**World Forum for Harmonization of Vehicle Regulations****Working Party on General Safety Provisions****131st session**

**Exchange of views on vehicle automation:****Categorization of automated vehicles and autonomous vehicle regulation screening****Proposal for supplement 5 to the original version of  
UN Regulation No. 151 (Blind Spot Information Systems)****Submitted by the expert from the Kingdom of the Netherlands\***

**"Annex 2 - Arrangements of approval marks**

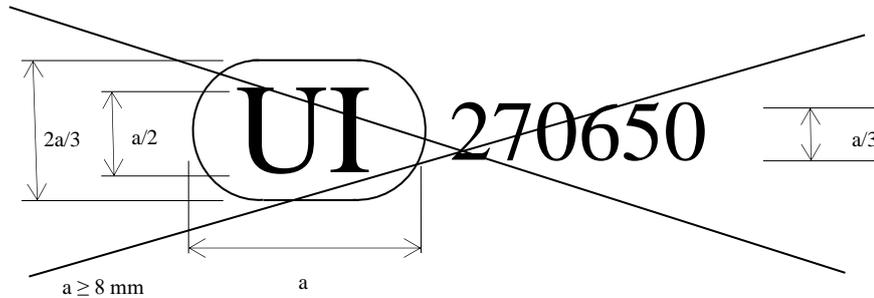
Annex 2, amend to read:

The above approval mark affixed to a vehicle shows that the vehicle type concerned has been approved in Germany (E1) with regard to BSIS pursuant to UN Regulation No. 151. The first two digits of the approval number indicate that the approval was granted in accordance with the requirements of UN Regulation No. 151 in its original form.

The above Unique Identifier shows that the type concerned has been approved and that the relevant information on that type approval can be accessed on the UN secure internet database by using 270650 as Unique Identifier. Any leading zeroes in the Unique Identifier may be omitted in the approval marking."
